SRR-CWDA-2019-00101

**ACTION ITEM FOLLOW-UP IN SUPPORT OF U.S. NUCLEAR REGULATORY
COMMISSION F AND H AREA TANK FARMS AND SALT WASTE DISPOSAL
MONITORING ACTIVITIES**

Figure 1. Groundwater particle tracks simulated with GSA2018.LW flow model near Tank 8 and the F-Area Inactive Process Sewer Line (FIPSL). Forward and backward tracks denoted with blue and red arrows respectively.

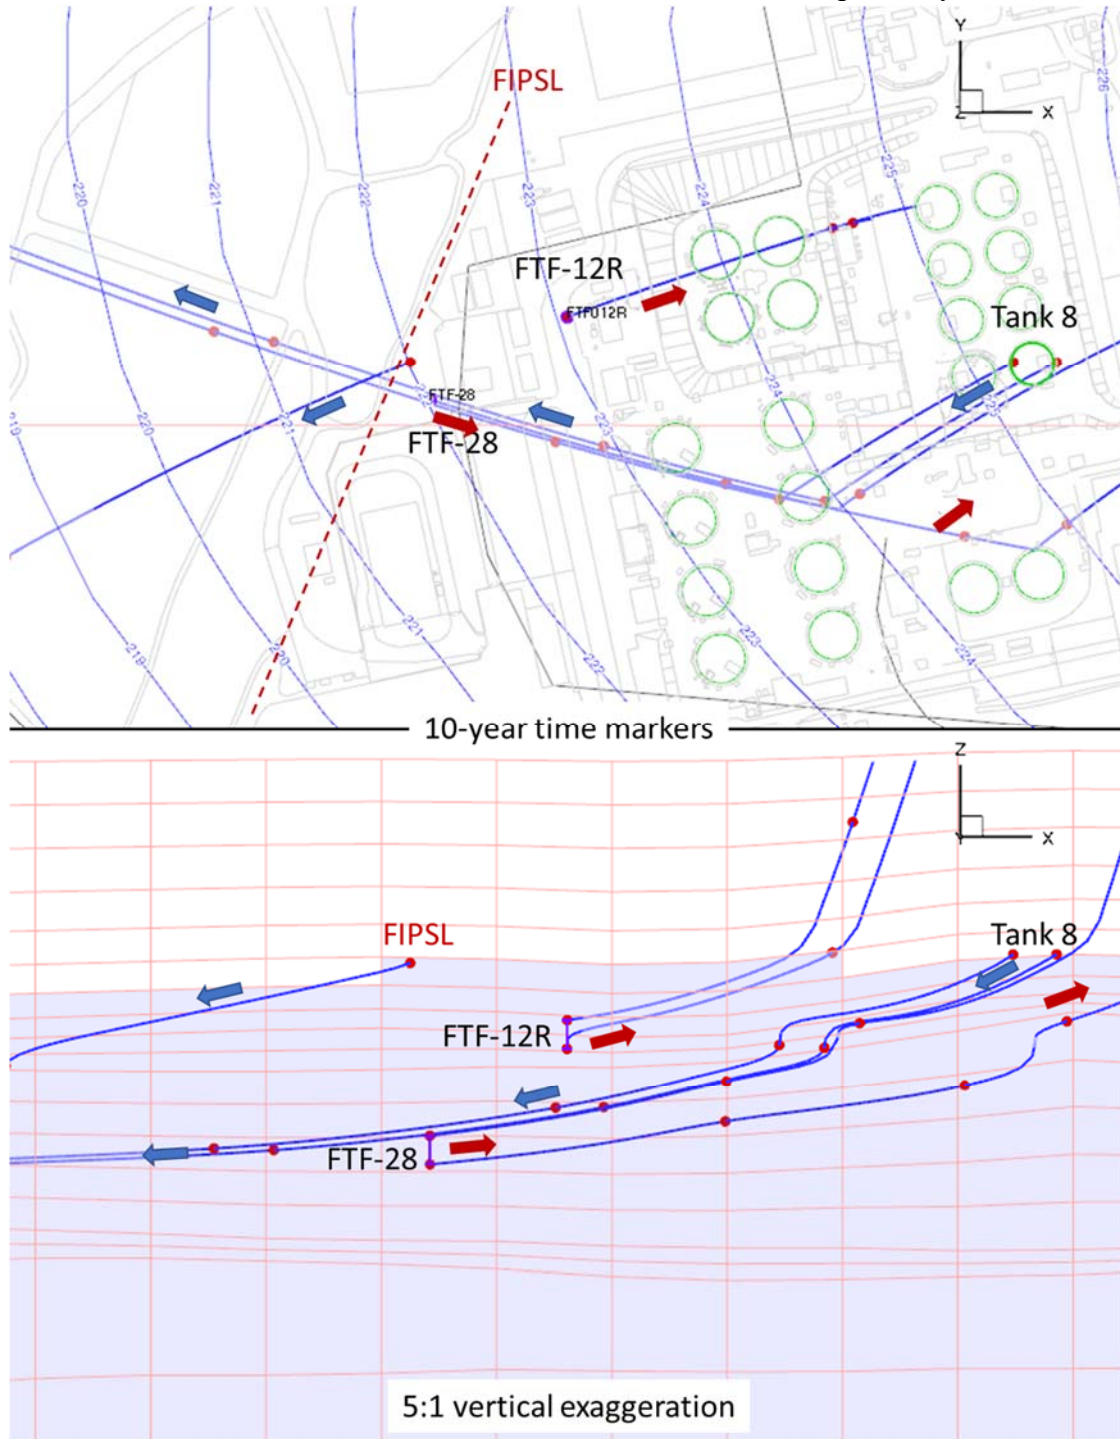
- NRC # TFs-CY19-01-007 (Action Item #7 from 3/2019 OOV, Reference 1)
 - *DOE to conduct particle tracking using GSA_2018 model: a) forward tracking from potential FIPSL and Tank 8 sources, b) reverse tracking from FTF-28 and FTF-12R monitoring wells, and c) reverse tracking from those Crouch Branch seepage areas above the Tan Clay Confining Zone.*
- NRC # TFs-CY19-01-010 (Action Item #10 from 3/2019 OOV, Reference 1)
 - *DOE to provide NRC and SCDHEC with a GSA_2018 model water budget summary comparable to Figure 46 in WSRC-TR-96-0399 Revision 1.*
- NRC # TFs-CY19-01-011 (Action Item #11 from 3/2019 OOV, Reference 1)
 - *DOE to provide NRC and SCDHEC with GSA_2018 model cross section views similar to Figure 2-8 in WSRC-TR-2004-00106.*
- NRC # SDF-CY16-01-013 (Action Item #13 from 4/2016 OOV, Reference 2)
 - *DOE to provide NRC with velocity field and cross-section through Z-Area.*

Figure 1 illustrates reverse groundwater particle tracks emanating from the top and bottom of the FTF-28 and FTF-12R well screens. Also shown are forward tracks from the upgradient and downgradient sides of Tank 8, and one forward track from the F-Area Inactive Process Sewer Line (FIPSL) near FTF-28 and FTF-12R.

Figure 6. Reproduction of Figure 46 from WSRC-TR-96-0399

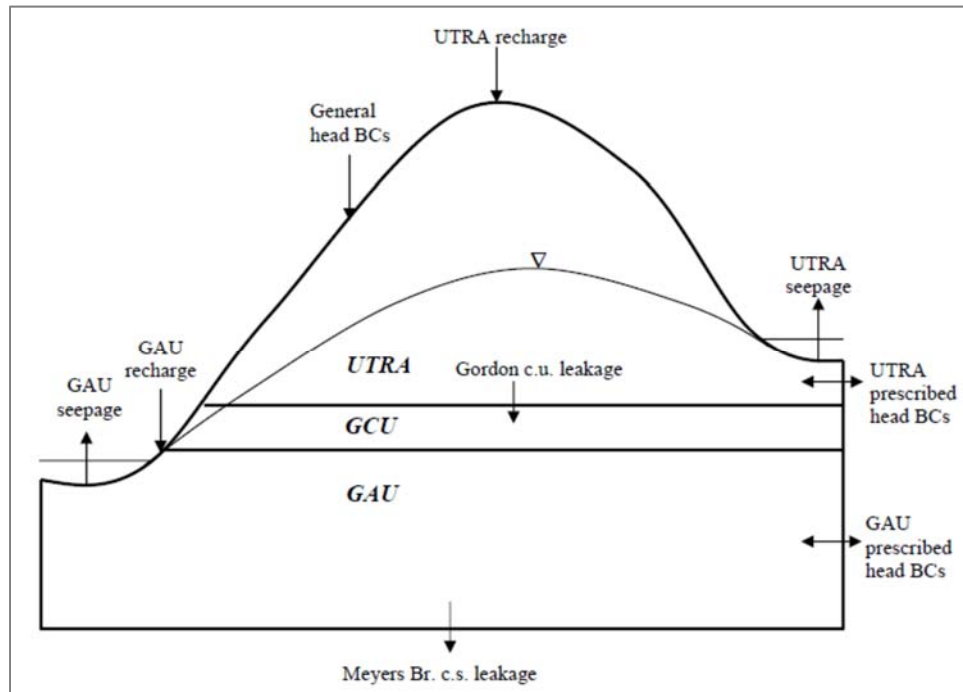
NRC # TFs-CY19-01-010 (Action Item 10 from 3/2019 OOV)

Figure 6 and Table 1 provide a water budget for the GSA2018.LW groundwater flow model that is comparable to Figure 46 in WSRC-TR-96-0399 Revision 1 (Reference 3).

Figure 7. North-south cross-section of GSA2018.LW velocity field through E-Area; vectors are fixed length showing flow direction only.

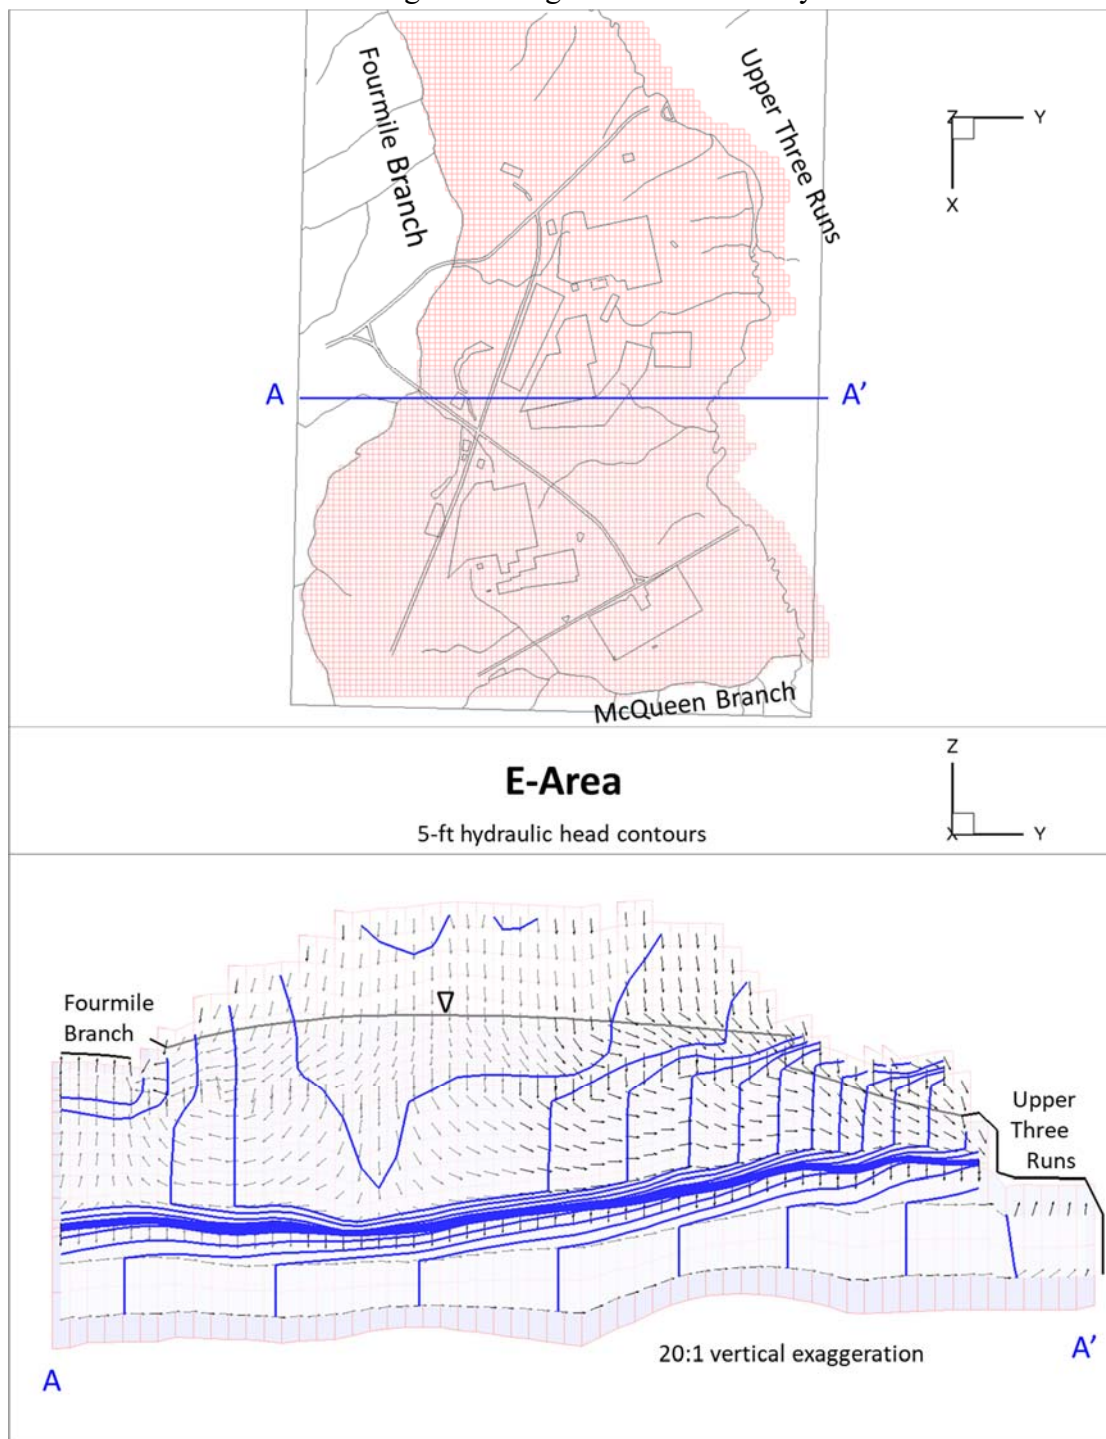
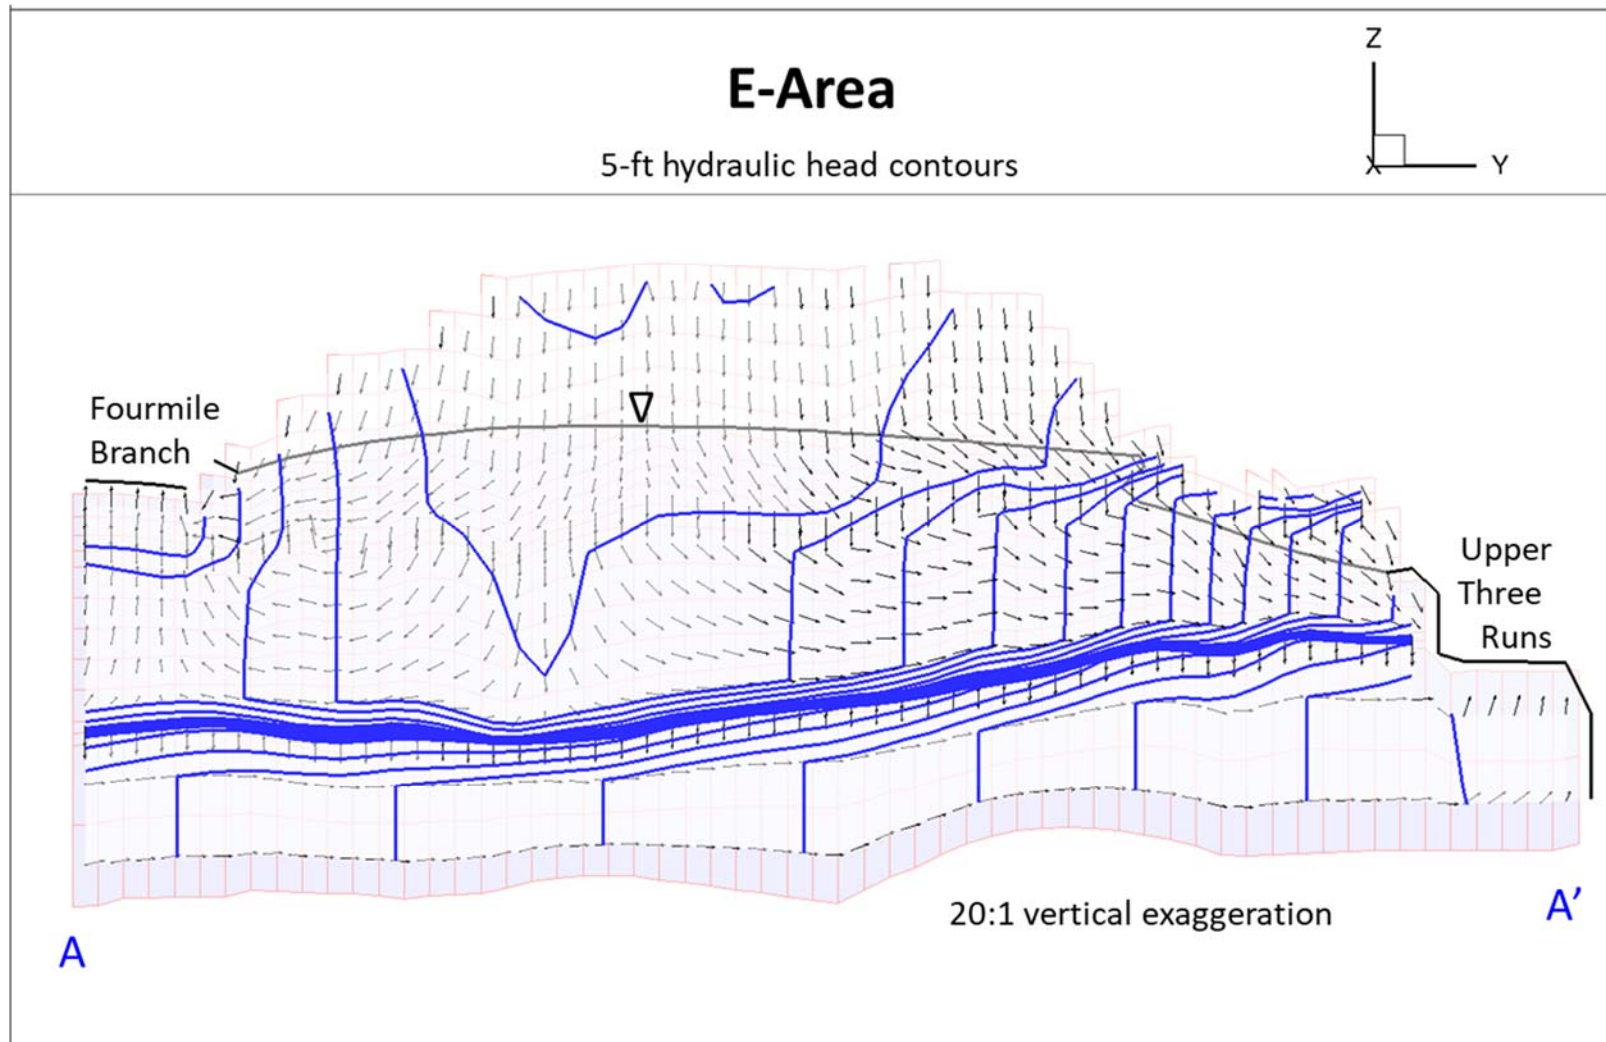
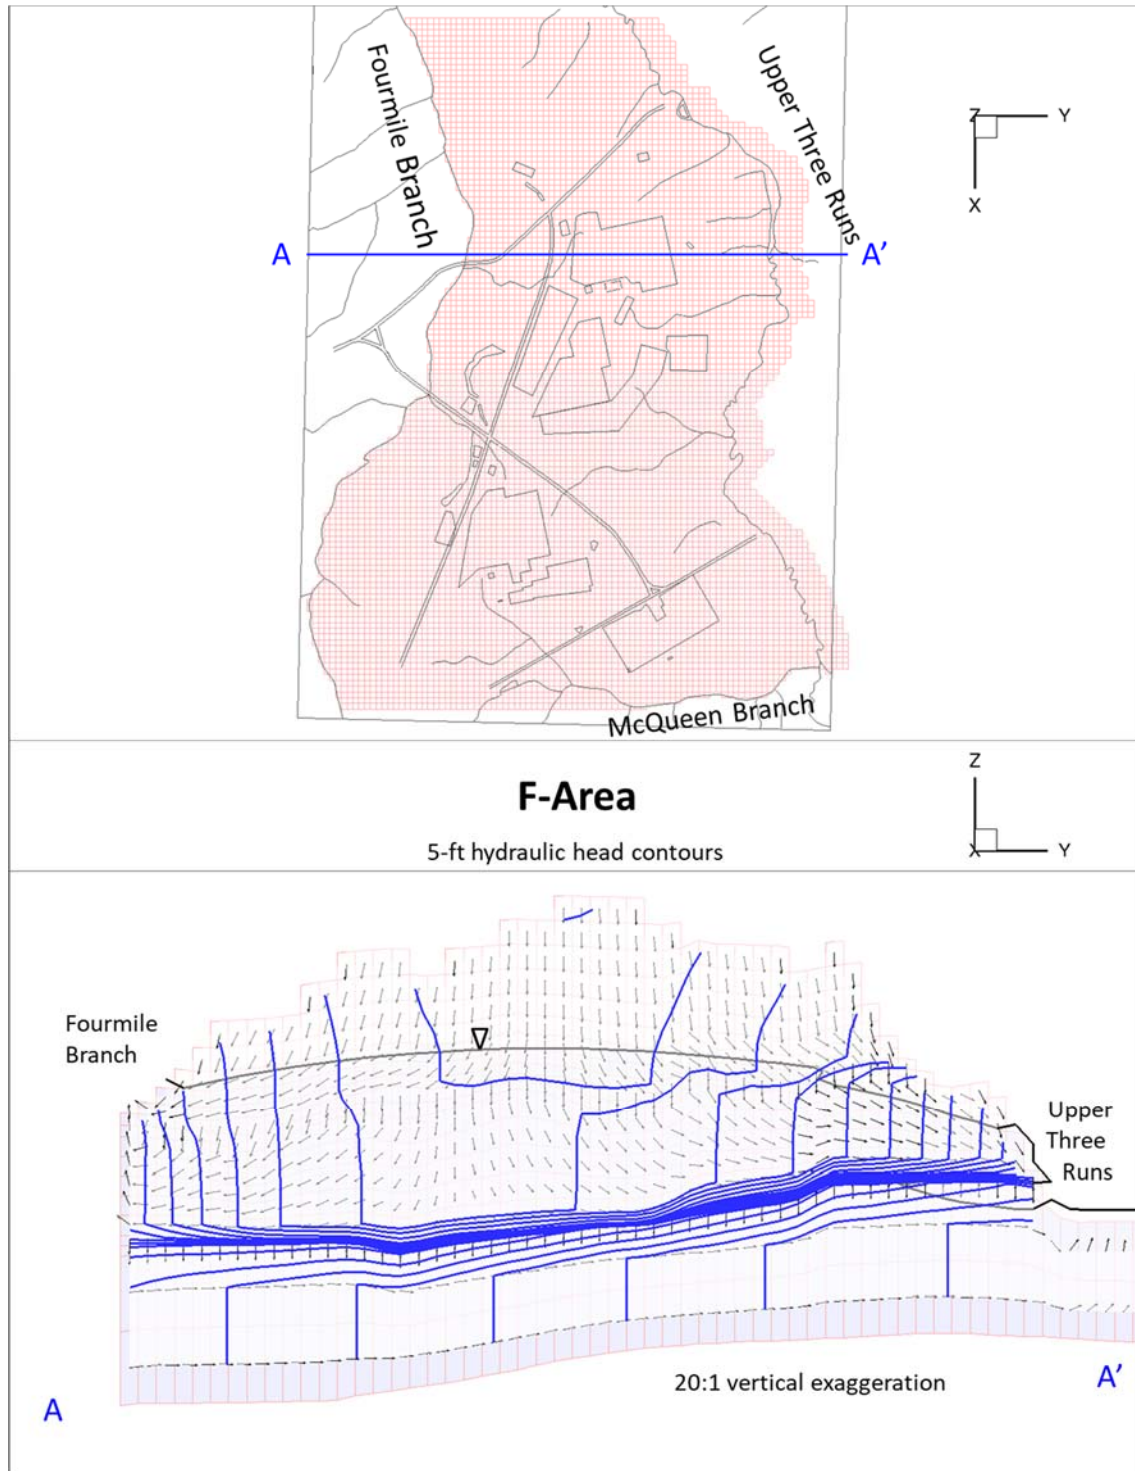
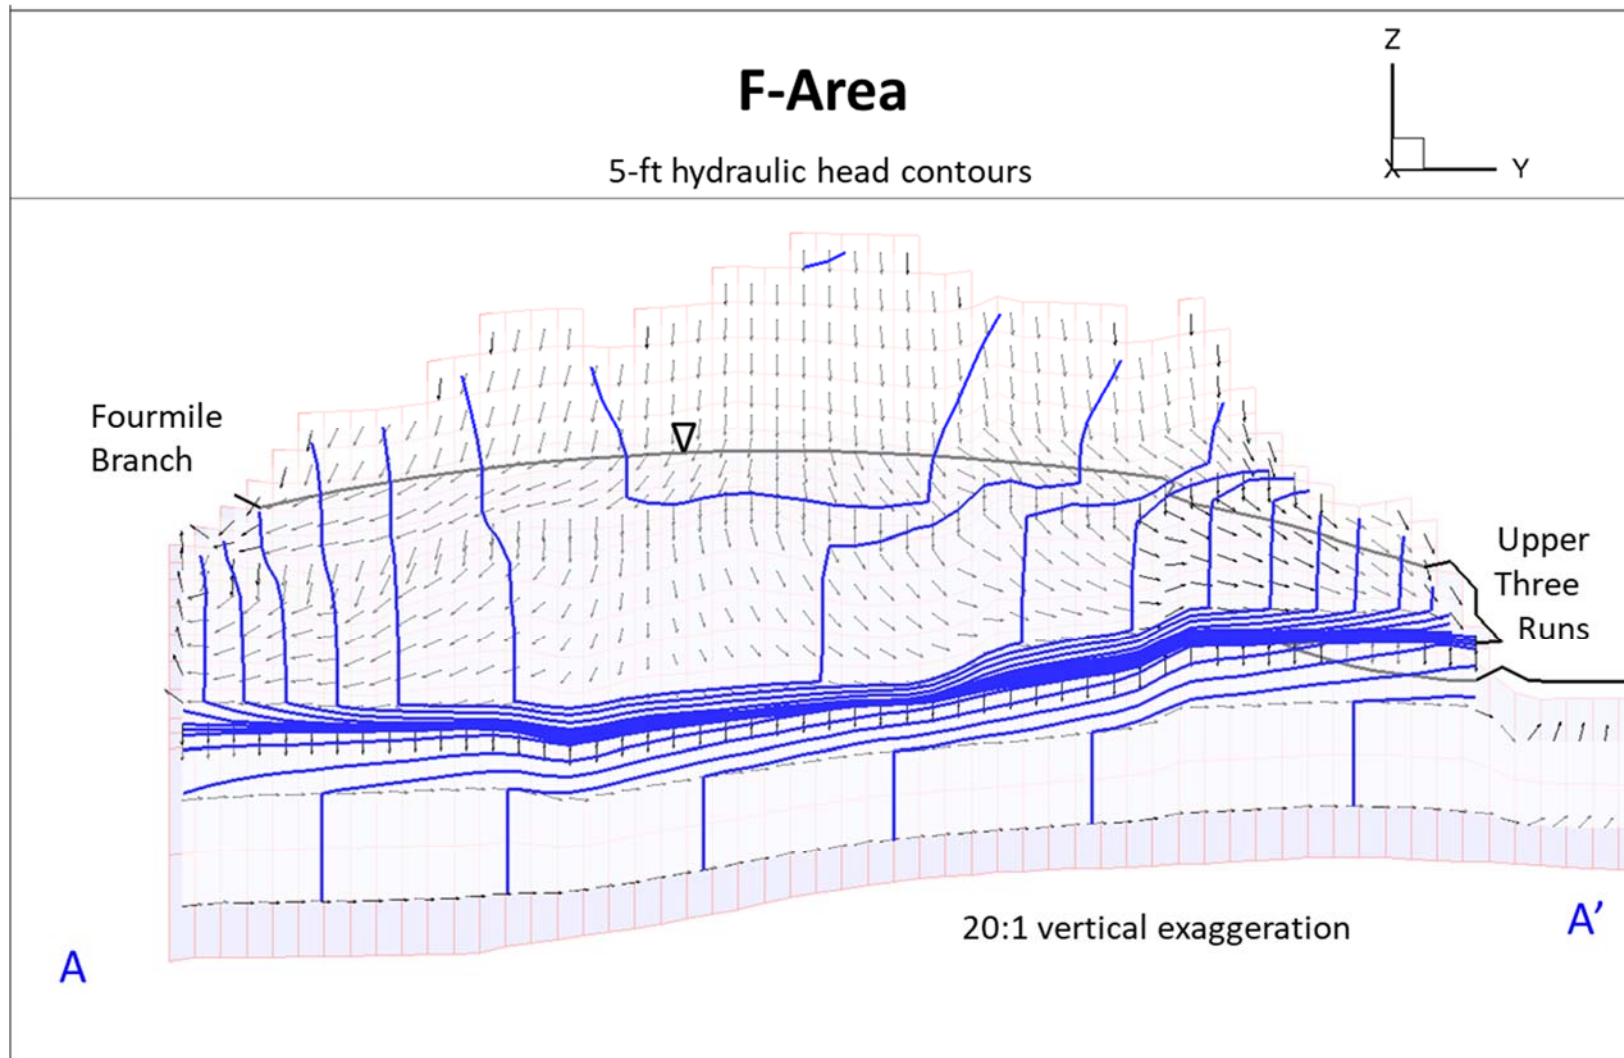
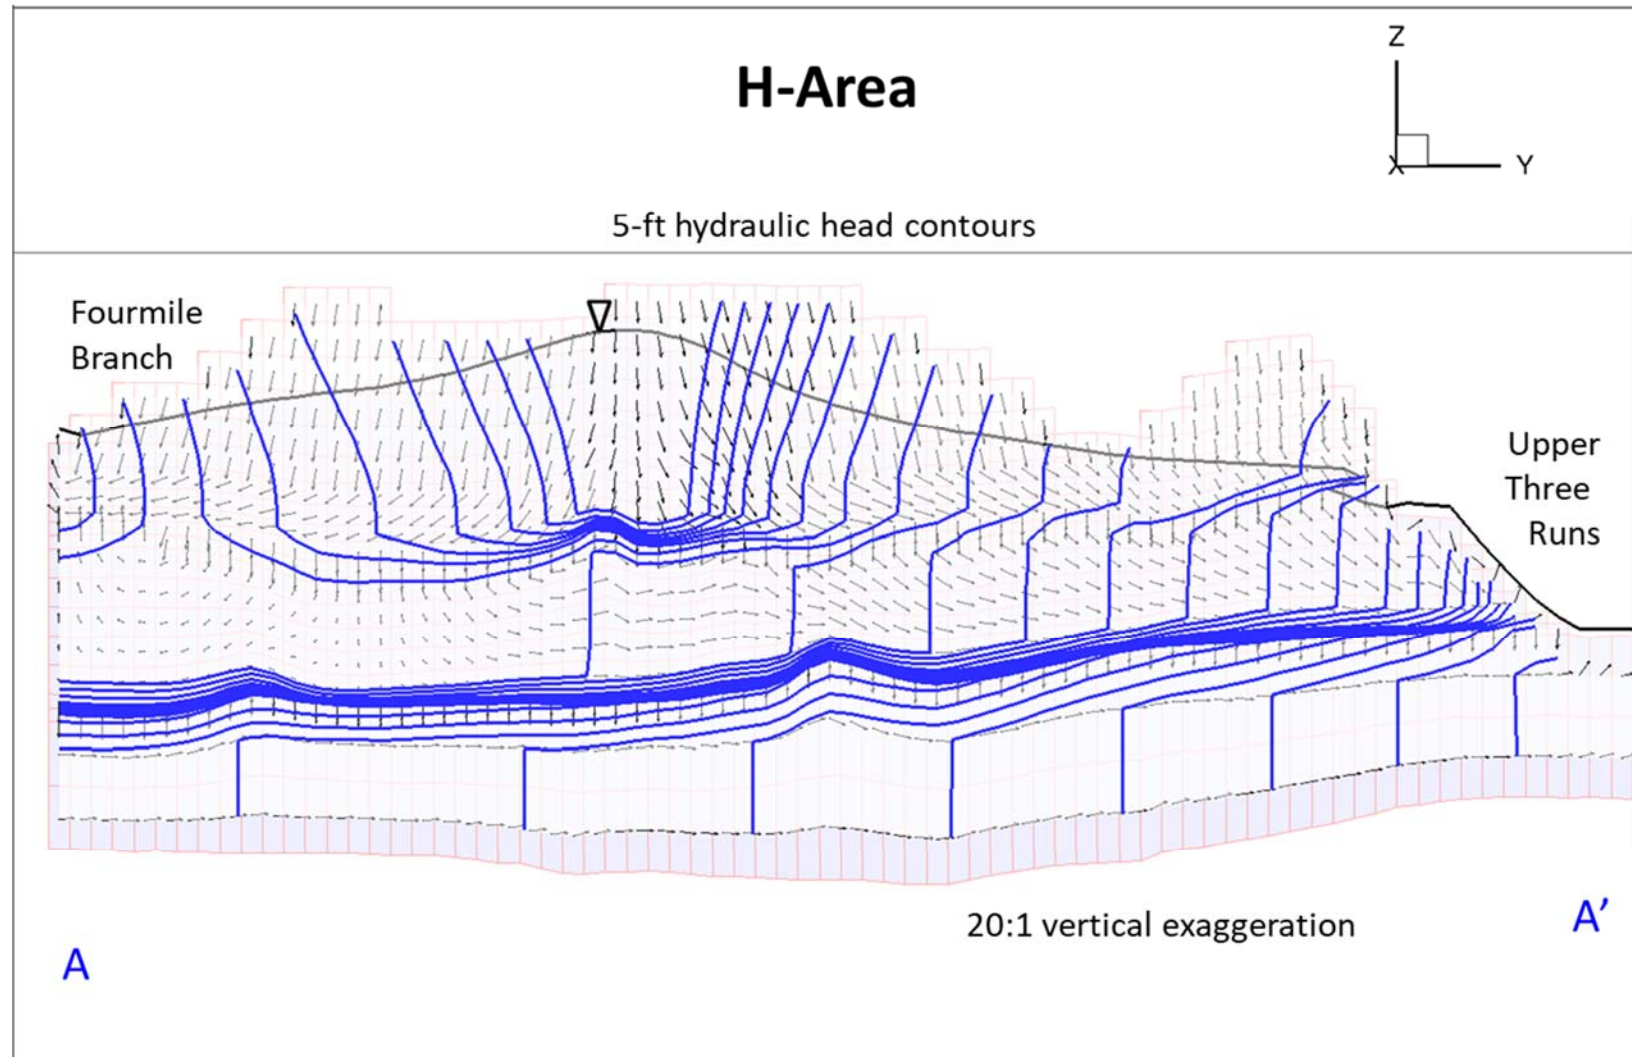
NRC # TFS-CY19-01-011 (Action Item 11 from 3/2019 OOV) and NRC # SDF-CY16-01-013 (Action Item #13 from 4/2016 OOV)

Figures 7 and 8 provide a cross-section of the GSA2018.LW velocity field through E-Area comparable to Figure 2-8 in WSRC-TR-2004-00106 (Reference 4). In addition, Figures 9 through 14 provide similar cross-sections for F-, H- and Z-Areas. Figures 15 through 20 provide cross-sections in the east-west direction for F-, H- and Z-Areas.
